Reply to comments of Anonymous Referee #1

General comments

Fig. 1C. Location map of rainfall stations for the study catchments

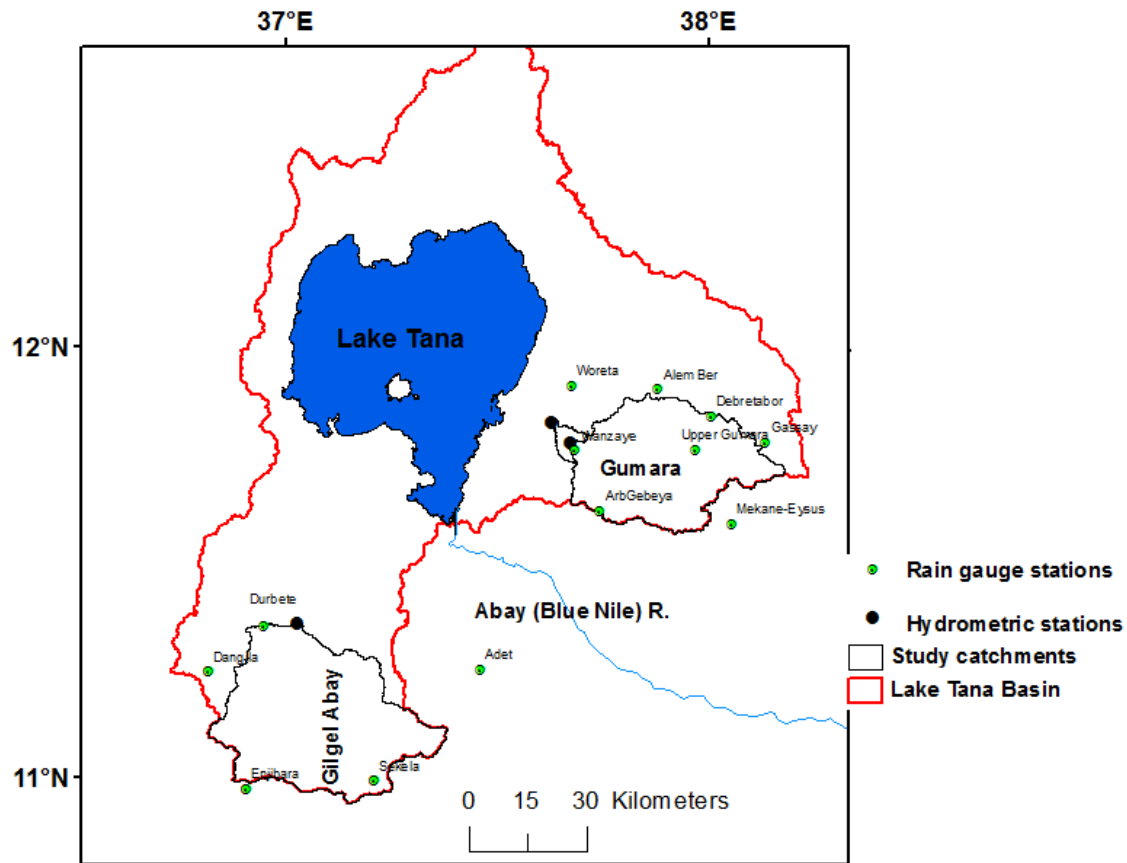
5300, 12. We need to see location map of these gauges – as precipitation is the key input –and know something about their accuracy. Was the PE spatially variable? What assumptions have been made about stream flow routing and stream-groundwater interactions?

The location map of the rain gauges is provided below and will be included in the revised version of the paper.

Generally rainfall data are obtained on daily basis. The data for most of the stations are consistent and continuous, particularly for first class stations like Dangila, Adet and Debreabor. However, we encountered gaps in some stations like Sekela Station for some periods in the year. In such instances, only the rainfall data from the other stations is considered. As discussed in the paper, most of the rainfall stations in Gilgel Abay catchment are installed at the water divides and there is no station in the middle of the catchment. In this regard, the Gumara catchment is with higher density of rainfall stations. PE is also spatially variable.

Fig.2C. Comparison of predicted and observed discharge together with the error (difference of the two) and precipitation of the Gumara and the Gilgel Abay catchments for the calibration period

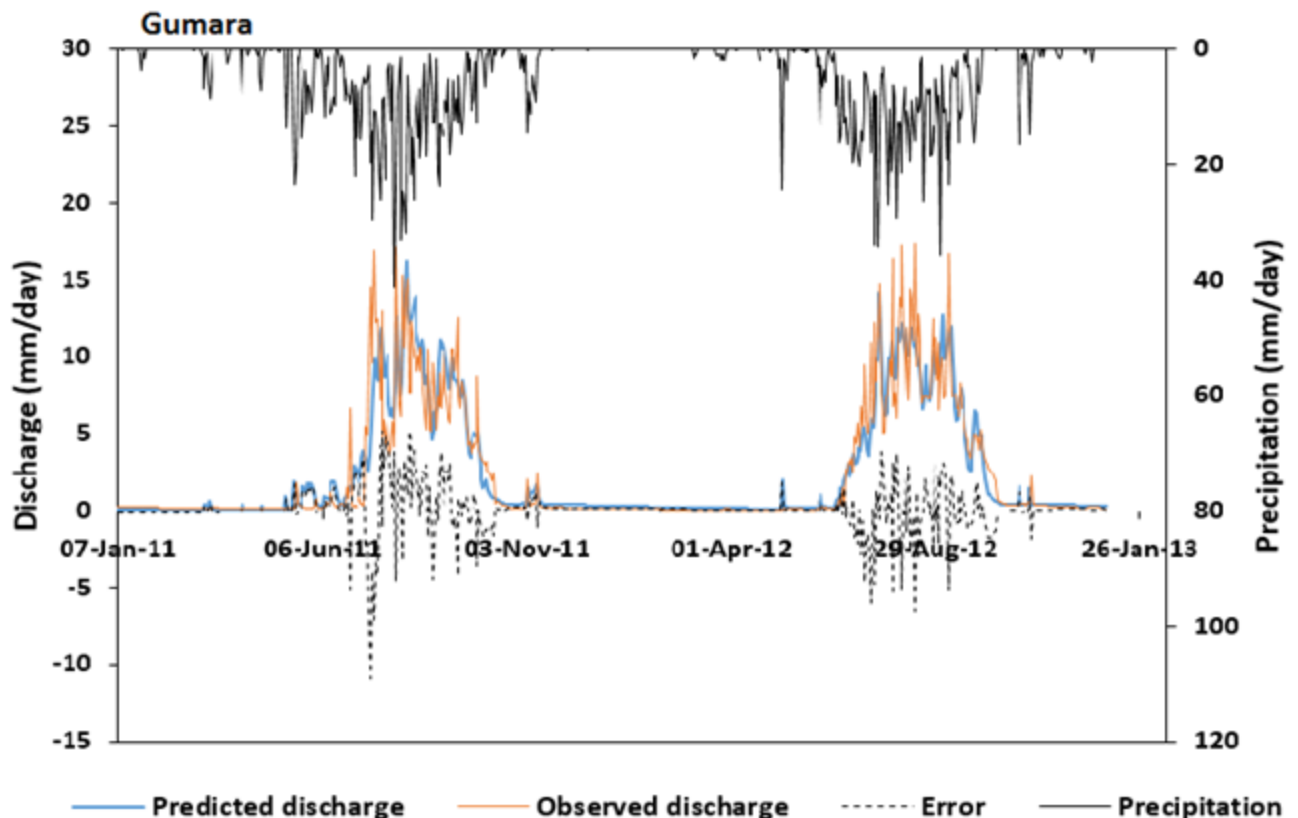
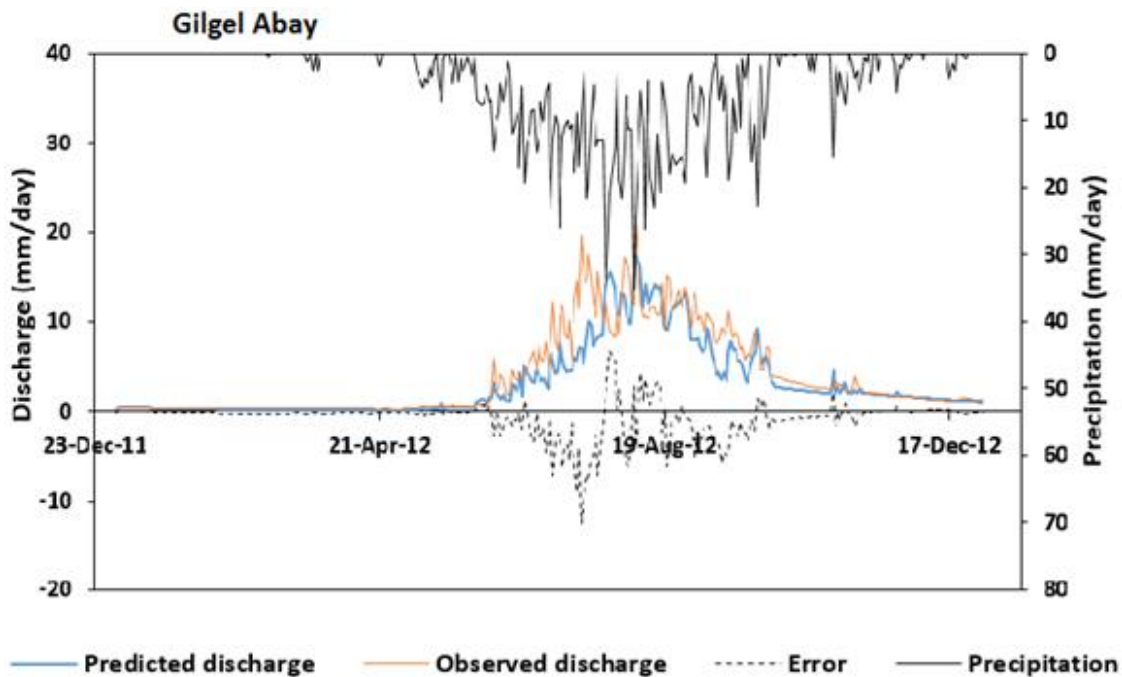
Figure 6. Does not look like great performance to me. Needs some more insightful plots to elucidate magnitude and nature of errors.

The quality of the model outputs and the errors associated with them are usually evaluated based on model performance indicators like the Nash-Sutcliffe Efficiency (NSE), Root Mean Squared Error (RMSE), the coefficient of determination (R^2), Bias, etc. The visual comparison (Plots) can also give an overall judgment. The authors used NSE, RMSE and R^2 in addition to the plot comparison of the observed and simulated outputs. The statistical results for NSE and R^2 were greater than 0.7, which shows the good performance of the model. The plots of the simulated and observed discharges of Figure 6 in the paper can show this, but it is true that there are some deviations of the simulated discharge from the observed ones at some points in the time series. There can be various reasons for this, as explained in the paper. One instance can be the rainfall data. As can be seen from Fig.1C, there are no rain gauges in the middle of the Gilgel Abay catchment and given the high spatial variability of the rainfall in the whole Blue Nile basin, this can create its own uncertainty on the model performance.

Fig.2C. below shows plot of the errors (difference of predicted discharge to observed discharge) to give more insight to the errors for Figure 6 in the paper.

Fig. 3C. Stage-Discharge relationship (Rating curve) for Gumara at Wanzaye Station

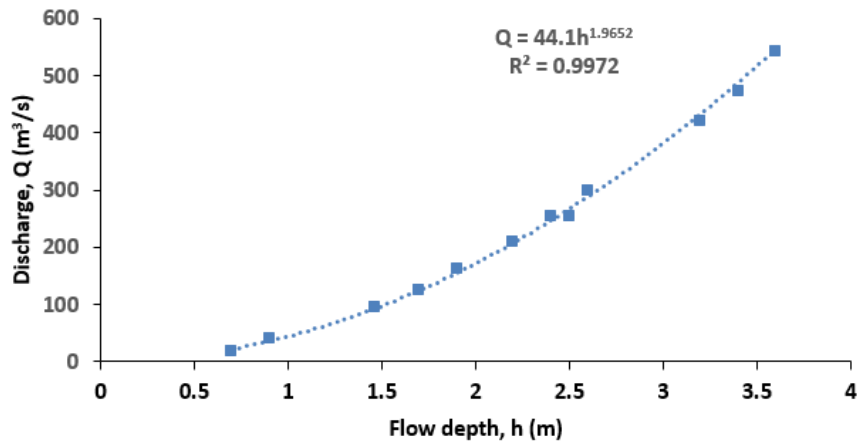
Eq 20, 21. Authors claim that the gauged flow data are high accuracy – it would be useful for the reader to see the rating curves, together with the range of levels to which the rating curves were applied.

The rating curves together with the range of levels to which the rating curves were applied have been provided below (Fig.3C and Fig.4C). We will also incorporate the figures in the revised paper.

Fig.5C. The three slope categories for the Gilgel Abay and Gumara catchments

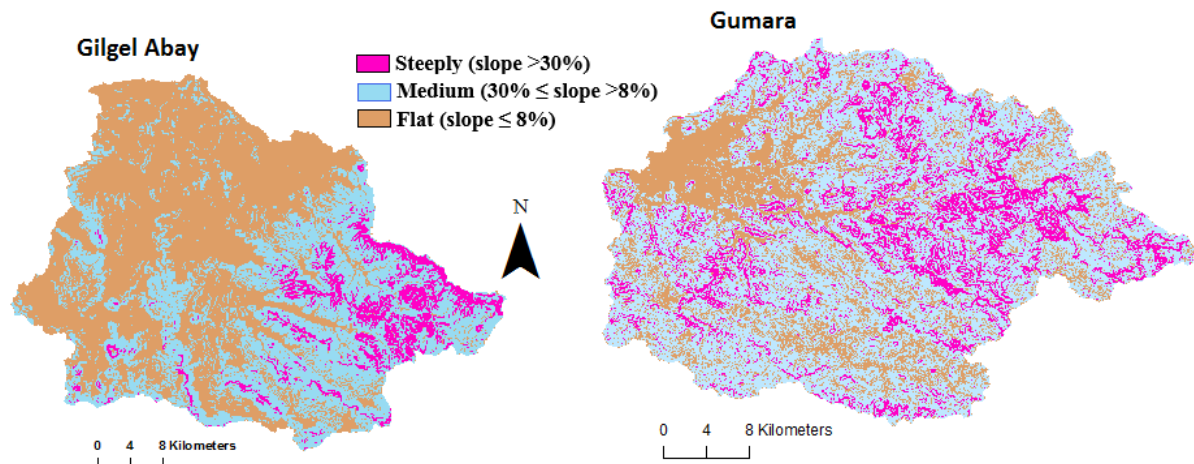
Can the splitting into three areas be shown on a map, e.g. using color coding?

Fig.5C. shows the splitting of the Gilgel Abay and Gumara catchments (the study catchments) into three slope categories (steeply, medium and flat slope surfaces).

Fig. 6C. Comparison of predicted and observed discharge together with the error (difference of the two) and precipitation of the Gumara and the Gilgel Abay catchments for the calibration period

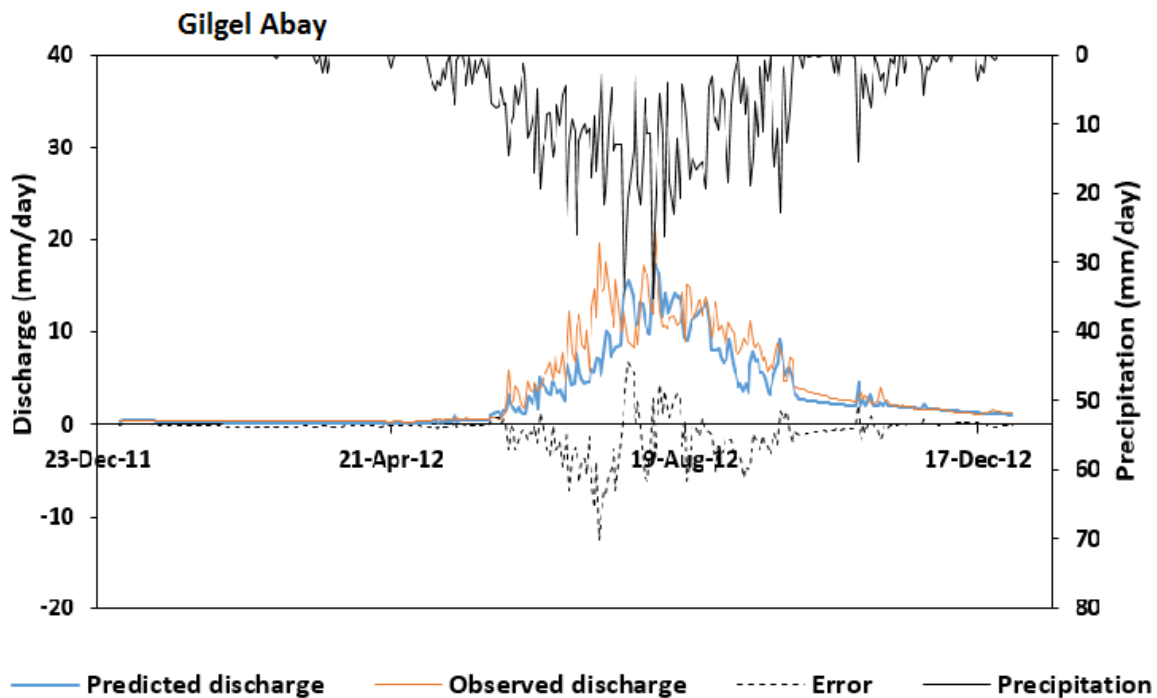
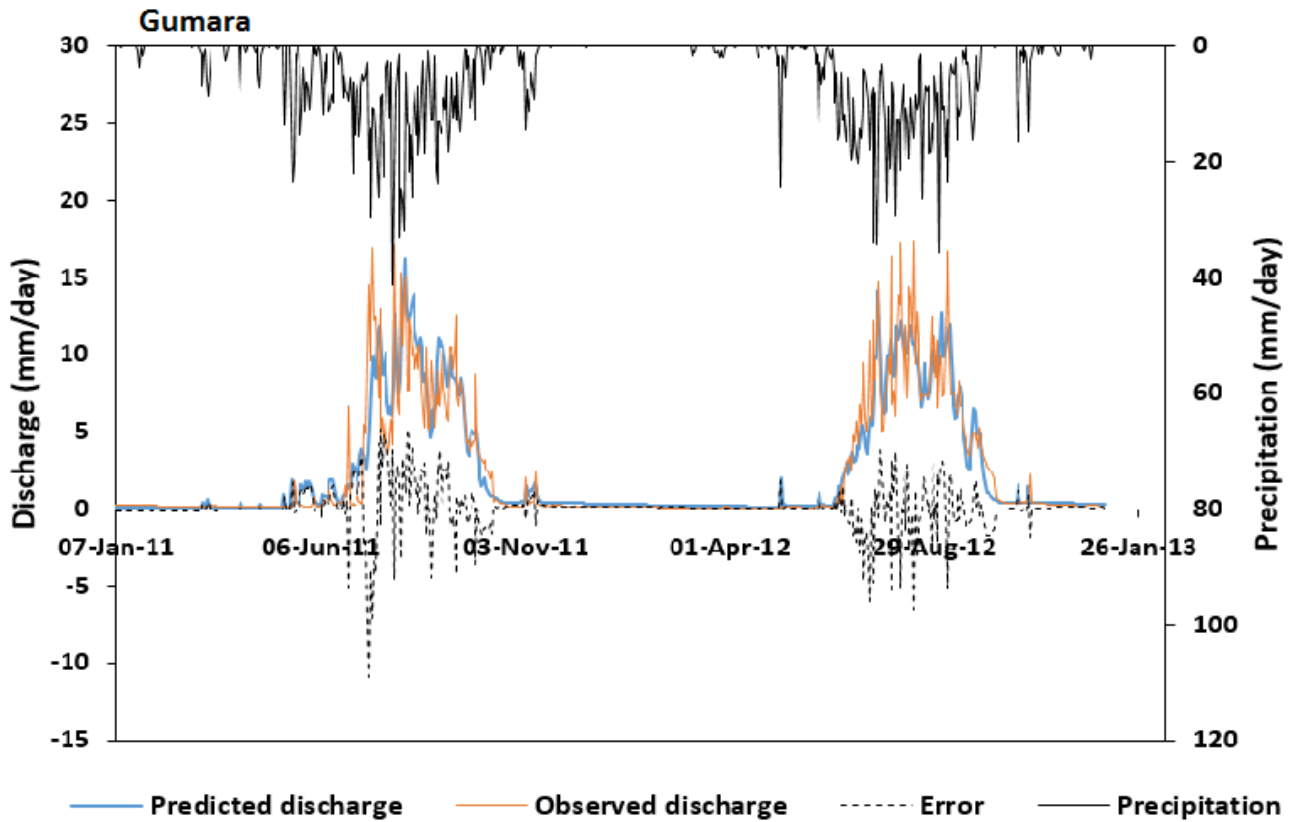
5304, 5. Figures 5 and 6 do not show this very well. Some more insightful plots about the errors are needed. In Figure 5, it seems there are some rather serious errors. E.g. the wetting up period deserves some discussion, In Fig 6, I cannot really see the nature or magnitude of the errors; however there are clearly some systematic errors that need critical discussion. The flow regime / climate in the validation period seems quite similar to the calibration period, so comparable performance is expected. Validation should ideally test the model to breaking point.

This comment is similar to one of the comments above. Figures 5 and 6 in the paper are plots of predicted and observed discharge and precipitation of the Gumara and the Gilgel Abay catchments for the calibration and validation periods. We still believe that the plot simulates well the general behavior of the observed streamflow hydrographs. Fig.6C and Fig.7C below show plot of the errors (difference of predicted discharge to observed discharge) to give more insight to the errors. Generally, the errors look to have no trend. However, we notice that the model errors tend to increase during wetting up periods in most instances. Initially, the soils are relatively dry and most of the rainfall during the beginning of the rainy season is not effective to produce runoff in the model as the soil reservoir has to be filled first to generate the faster component of the runoff. In the model, mostly average conditions prevail owing to average input data (rainfall, soil, catchment characteristic, etc.). Besides model uncertainties, the rainfall data quality can also affect the model performance, mainly in the case of the Gilgel Abay catchment as discussed in the paper.

Fig.8C. Model parameter sensitivity analysis for Gumara catchment. Parameters are explained in table 2 in the Paper.

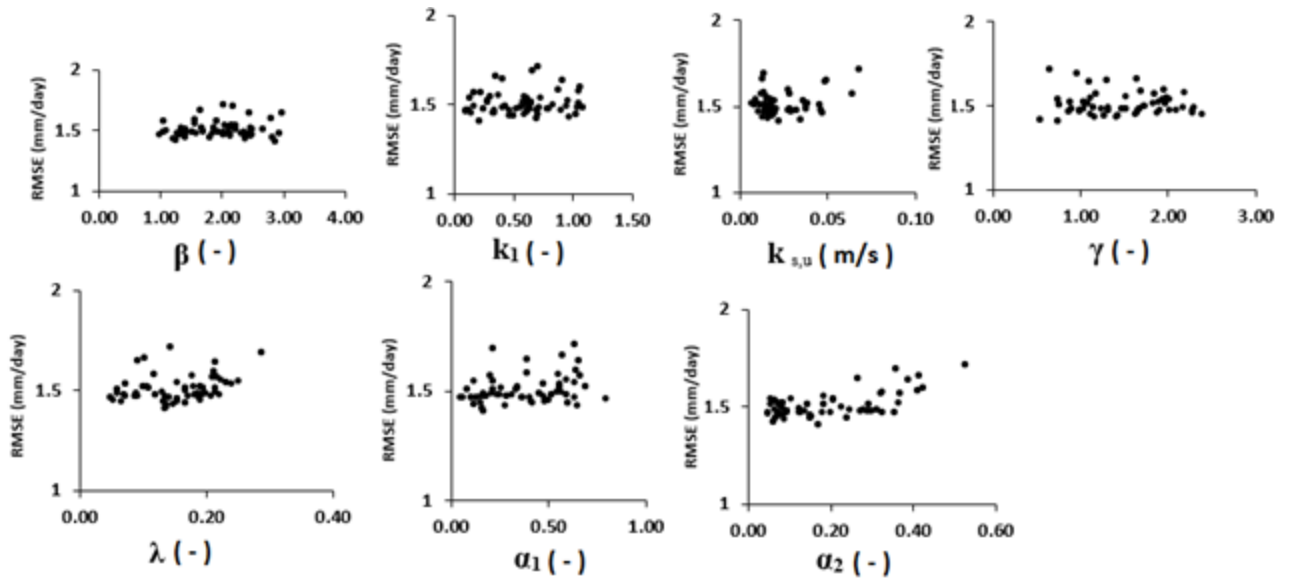
Figure 7. Local sensitivity analysis – value of this is unclear give high uncertainty in parameter values. Global analysis would be more useful.

5307 - Sensitivity analysis results support the view that the model is too complex; or at least components of it are too complex

The reviewer's idea is not very clear here. In one case, he (she) states as the sensitivity analysis is unclear, but in another case gives comments based on the sensitivity analysis. The optimal model parameters are obtained using the particle Swarm Optimization (PSO) algorithm, which performs global analysis. In Figure 7 (in the paper), we investigated the sensitivity of each model parameter when the parameter value is different from the optimal one, keeping the other model parameter values constant (equal to the global optimal value). Based on the comments of reviewer 1, we also made global sensitivity analysis and results are depicted in Fig.8C.
